Responses to CEC Data Requests (#1–48)

Application for Certification (08-AFC-6) for **WILLOW PASS GENERATING STATION** Pittsburg, California

December 2008

FIGURE 1-1

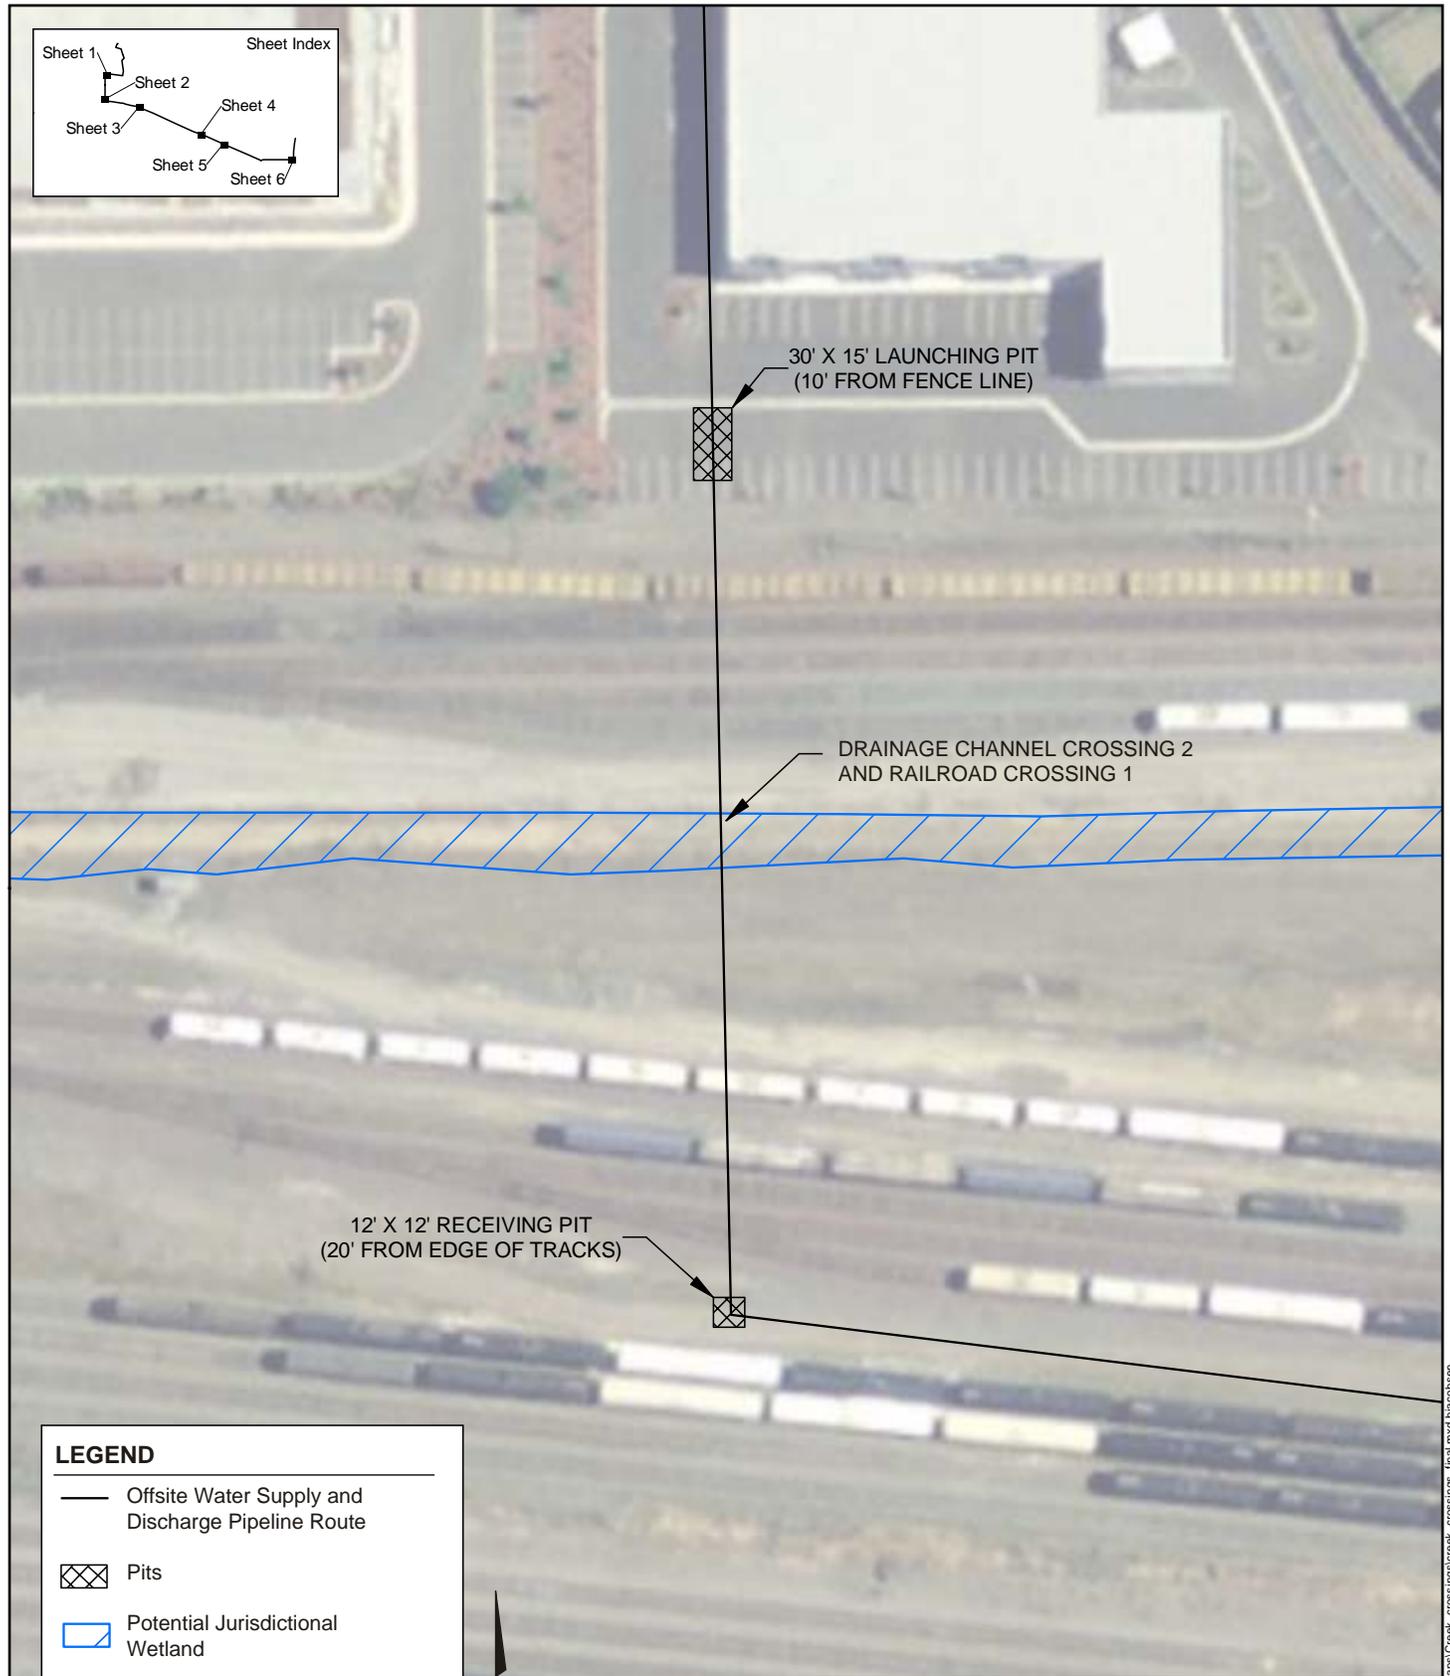
- 1. Please provide a summary of communication with the USACE regarding the need for a Section 404 permit, the CDFG regarding the need for a Streambed Alteration Agreement, and the RWQCB regarding the need for a Section 401 Water Quality Certification.***

Installation of the recycled water supply and wastewater discharge pipelines for the WPGS project would require crossings of five potentially jurisdictional wetlands, herein identified as Drainage Channel Crossings 1 and 2 (Figures 1-1 and 1-2) and Creek Crossings 1 through 3 (Figures 1-4, 1-5, and 1-6, respectively) (west to east). Figures 1-1 through 1-6 show the locations of all the crossings, including drainage creek and railroad crossings, for the water supply and wastewater discharge pipeline route. Table 1-1 presents a summary of the crossings, including installation method and potential agency permits required at each of the crossings.

Additional field investigations have confirmed that an open trench installation is a feasible method of crossing this drainage channel, while still avoiding impacts to potential jurisdictional wetlands. At the location where the new pipeline would intersect with the channel, the existing channel is conveyed underneath the access road to the power plant via a large culvert. The culvert extends beyond the edges of the access road, and is sufficiently long for the new pipelines to be constructed under or over the culvert, either in or adjacent to the power plant access road. Because all of the waters are contained within the culvert at this point, and the culvert would not be disturbed, there would be no impacts to potential jurisdictional wetlands or waters of the United States at Drainage Channel Crossing 1.

FIGURE 1-3

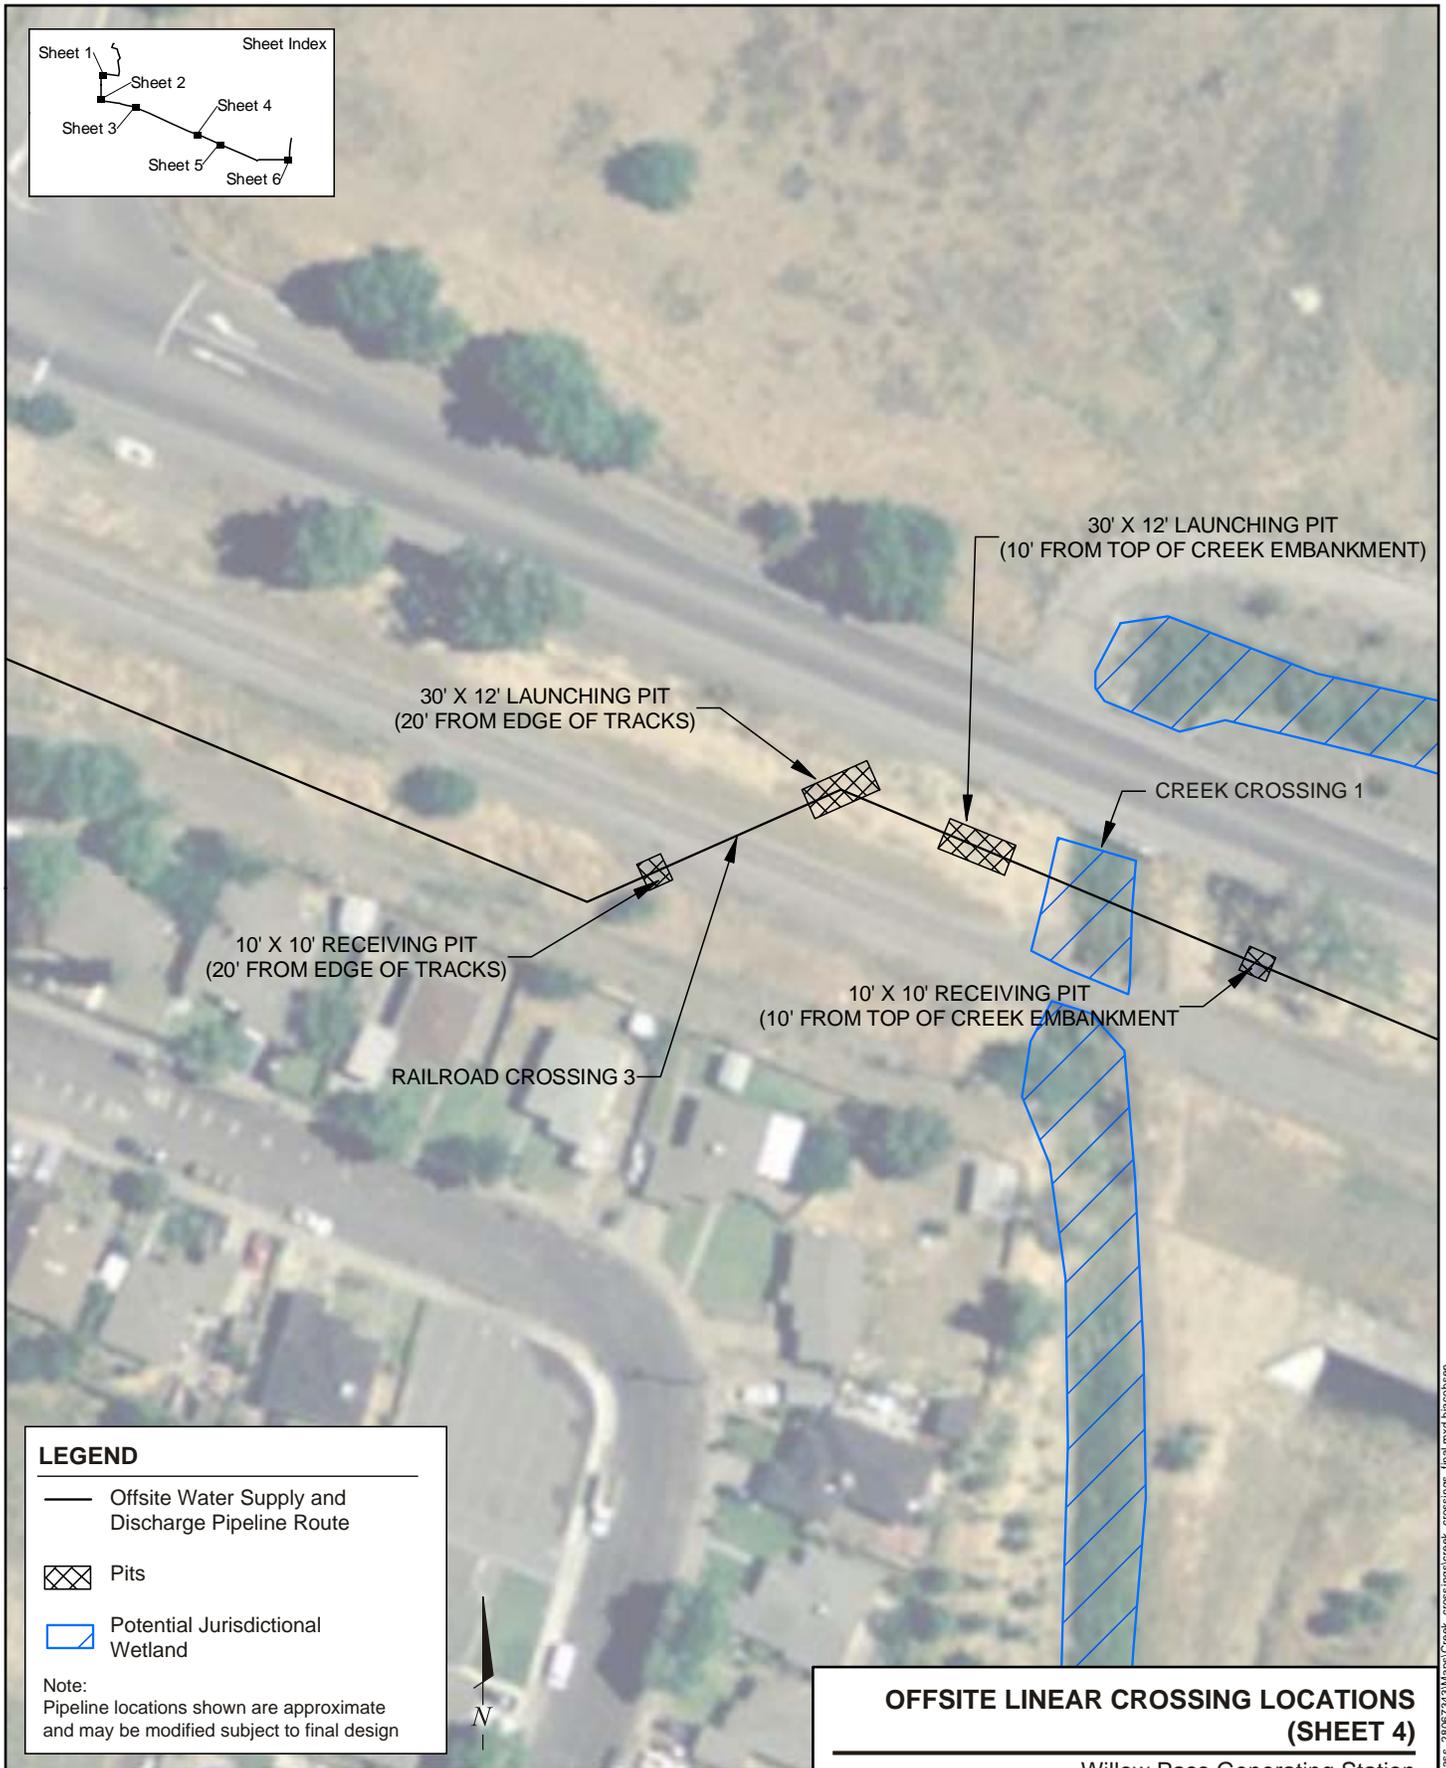
7. ***Please provide a map, at a scale appropriate to show the biological resources of the area, for each area where a jack and bore drilling operation would occur. On each map, identify the launching and receiving pits location in relation to the banks of the drainage channels and Kirker Creek and unnamed tributary. On each map, please provide the distances the launching and receiving pits would be from the drainage channels and Kirker Creek and unnamed tributary.***

- Railroad Crossing 2: Just to the west of the Kirker Creek crossing is a short railroad crossing. The required depth of this crossing will vary depending on what is required by the railroad. For now, it is assumed that a 10-foot-deep casing should be sufficient to provide enough separation from the live loads caused by passing trains. This results in 17-foot deep pits. This crossing would likely involve the use of the pipe ramming method.
- Railroad Crossing 3: Just west of the Railroad Avenue overpass, there is another short crossing under the railroad tracks. Pipe ramming, a 10-foot-deep casing, and 17-foot-deep launching and receiving pits are expected here as well.

Launching and receiving pits for Railroad Crossings 2 (Figure 1-3) and 3 (Figure 1-4) would be located in disturbed annual grasslands within the railroad corridor.

FIGURE 11-1

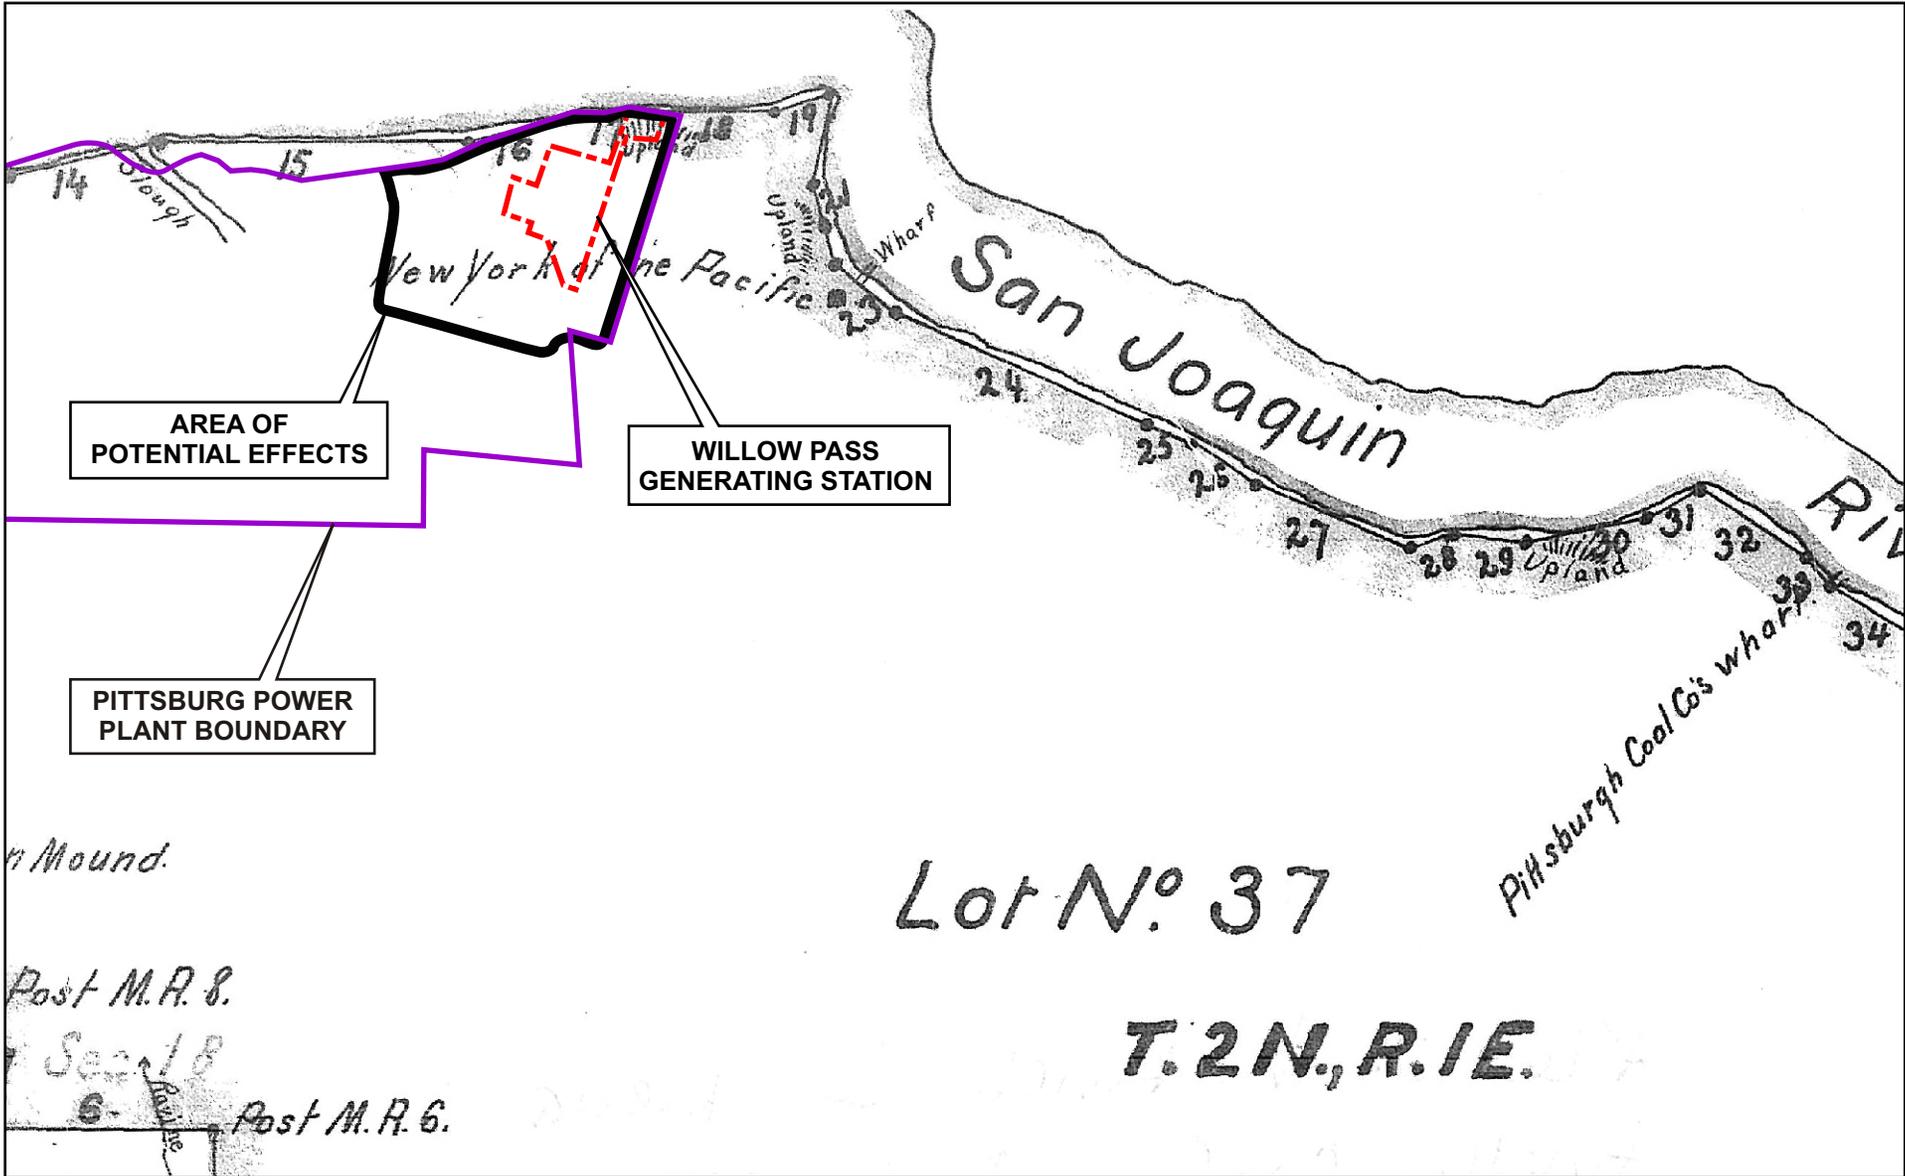
- 11. To enable staff to better assess the impacts to potential subsurface archaeological deposits, please provide a description of the excavation and grading for the project area, including the maximum depth of excavation for the major plant components that require foundations and footing. A grading site plan should be included with the description.***

Approximately 23.5 acres of the 26-acre WPGS site will be graded, which represents approximately 90 percent of the site. The proposed grading plan indicates an estimated cut of about 8,300 cubic yards (cy) and an estimated fill of 83,800 cy to achieve a plant site elevation after regrading ranging from 8 to 13 feet (msl). Thus, fills could be on the order of 3 to 5 feet thick (see AFC Figure 2.6-2). Topography changes as a result of grading are shown on Figure 11-1.

The site will be graded to final topographic levels as shown in AFC Figure 2.6-2. To provide further details on depths of excavation into existing soils, Figure 11-1 shows the expected change in topography of the WPGS site between pre- and post-project conditions. As shown, the only areas of the WPGS site where the final grade will be at levels below the existing grade are Tank 7 and a small area at the western portion of the WPGS site where the control building will be constructed. Therefore, excavations for foundations and footings will occur in fill as well as existing soils. The depth of excavation for major project components is listed below in Table 11-1, including the depth of excavation into existing soils.

Balance of Plant Equipment	Balance of plant equipment foundation depths are expected to range from approximately 3 to 5 feet, but maximum depths could be up to 10 feet following grading in the vicinity of Tank 7. For the majority of the site maximum excavations into existing soils would be 5 feet.
Piping Systems	The linear pipeline trenches are generally expected to be no greater than 5 feet deep.

FIGURE 26-1

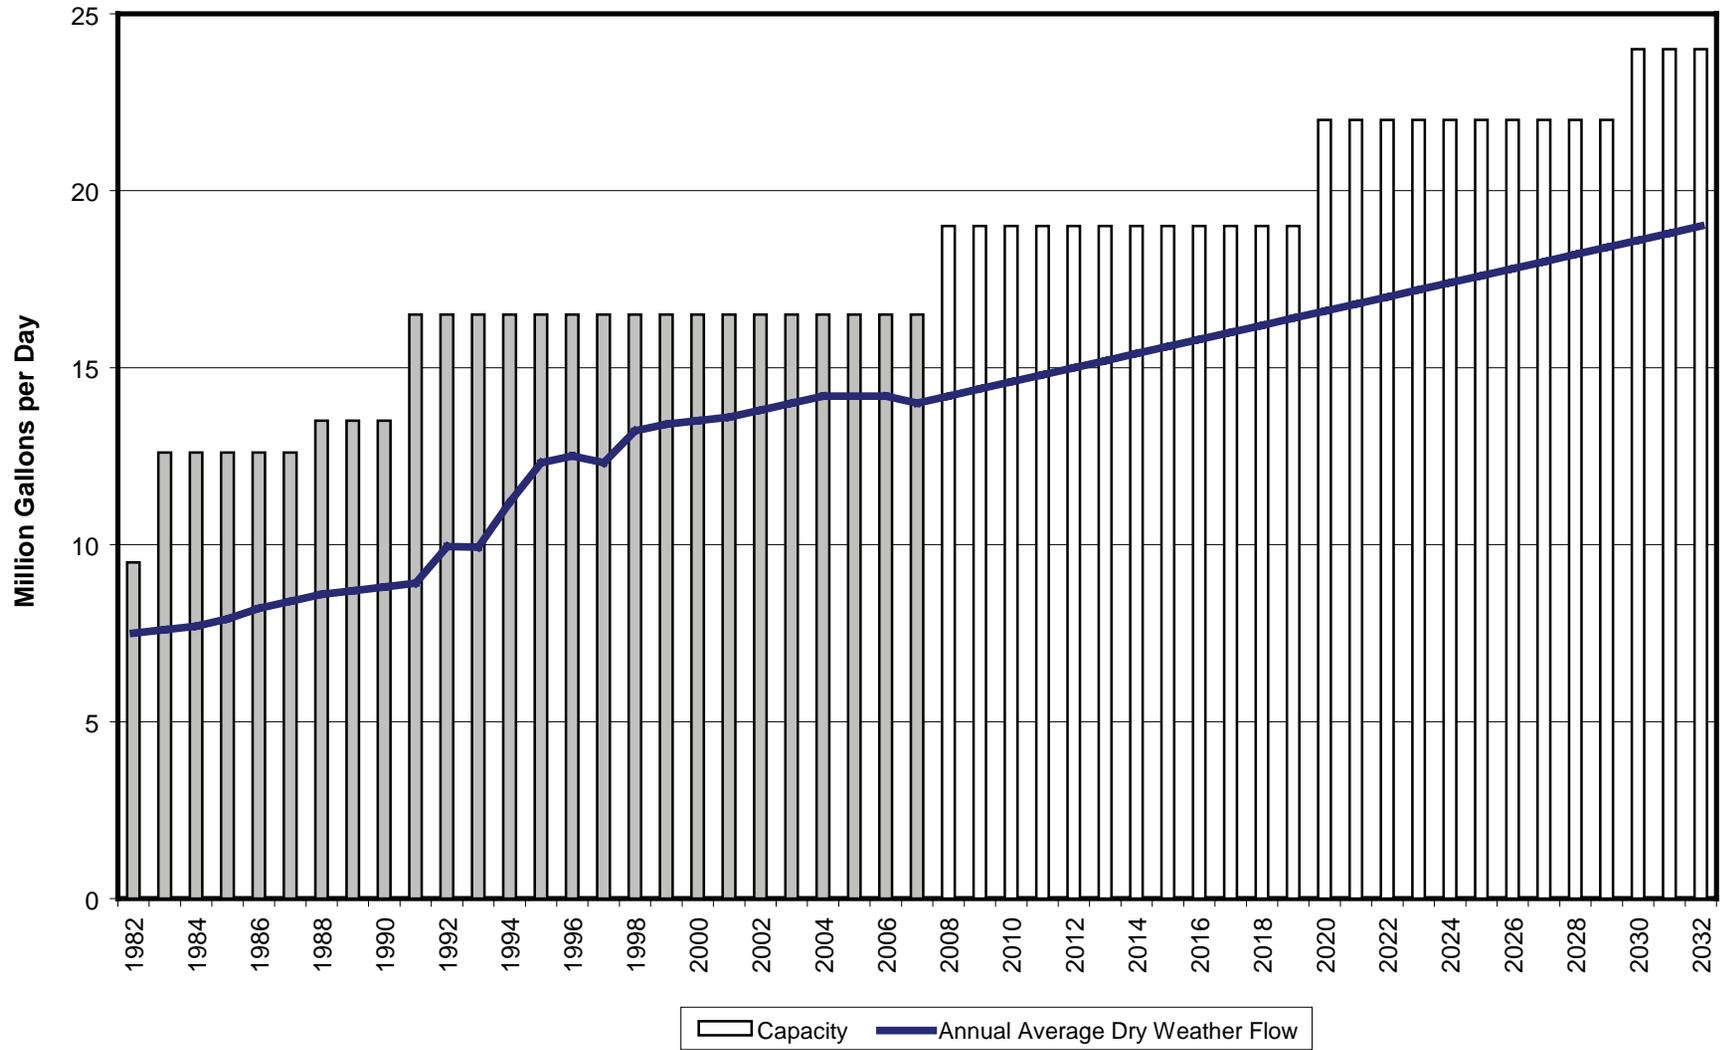
... staff has analyzed DDSD's current and expected plant flows for the years 2012 and beyond. Based on this analysis, DDSD has sufficient uncommitted quantities of recycled water to support Mirant's anticipated peak usage of 1.5 million gallons per day at peak flow rate of 1,400 gallons per minute of recycled water. This supply is in addition to the quantities of water described in my June 2, 2008 letter to you regarding your proposed Marsh Landing Generating Station, provided that Mirant incorporates an adequate volume of on-site storage and/or incorporates other operating flexibility into its plant design to meet the periods of DDSD's highest daily peak demand hours.
